## ADDENDUM IDAP REPORT

<b>Property:</b>	118-120 Homebush Road STRATHFIELD Lot A in DP 382199 DA 2021/41
<b>Proposal:</b>	Demolition of existing structures and construction of two (2) storey dwelling with basement level, front fencing and in-ground swimming pool.
<b>Applicant:</b>	A Mulder
<b>Owner:</b>	J M Chen and Z X Chen
<b>Date of lodgement:</b>	22 February 2021
<b>Date of IDAP Meeting:</b>	10 September 2021
<b>Notification period:</b>	5 to 19 March 2021
<b>Submissions received:</b>	One (1) submission
<b>Assessment officer:</b>	M Rivera
<b>Estimated cost of works:</b>	\$1,264,314.00
<b>Zoning:</b>	R2 – Low Density Residential - SLEP 2012
<b>Heritage:</b>	No
<b>Flood affected:</b>	No
<b>Is a Clause 4.6 Variation Proposed:</b>	No
<b>RECOMMENDATION OF OFFICER:</b>	<b>APPROVAL</b>

**Figure 2:** Amended design of void space (Section DD)

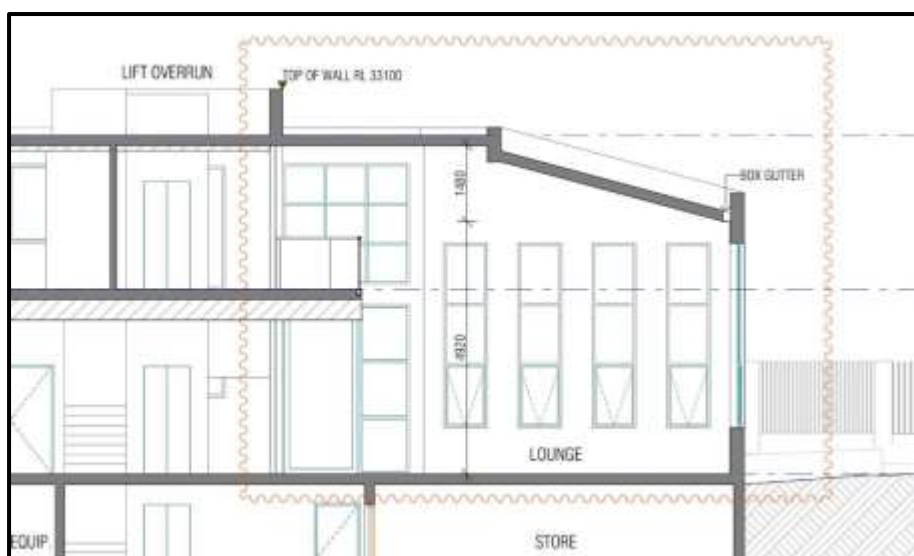
- i) provide fully dimensioned plans indicating room sizes and setbacks;*
- ii) provide plans that show that the void area over the ground floor living room is completely deleted as it adds unnecessary bulk and presentation to the street without providing any additional amenities to the occupants; and*
- iii) Provide plans that show that the internal hatch on the first floor providing access to the roof is completely deleted.*

- That the design – whilst maintain the void – presents a reduced bulk and scale and a visual presentation that incorporates a skillion roof. A maximum height of 5m to the top of the lower roof has been integrated into the design. This changed design in combination with the skillion roof provides a break-up of the visual continuity of the building and adds visual interest to the corner presentation, whilst ensuring the massing is acceptable and reasonable.

The amended design of the proposal includes a reduced floor to ceiling for the void area above the formal lounge room. The maximum floor to ceiling height of this area is approximately 6m; however, this tapers down with the pitch of the skillion roof – ensuring that the majority of the void space will have a floor to ceiling height of 4.92m (refer to Figure 2). This changed design ensures the bulk and scale of the overall scheme are reasonable and acceptable, presenting as a single storey element from public domain. Therefore, the amended design is considered supportable outcome that addresses the deferred matters raised by IDAP.
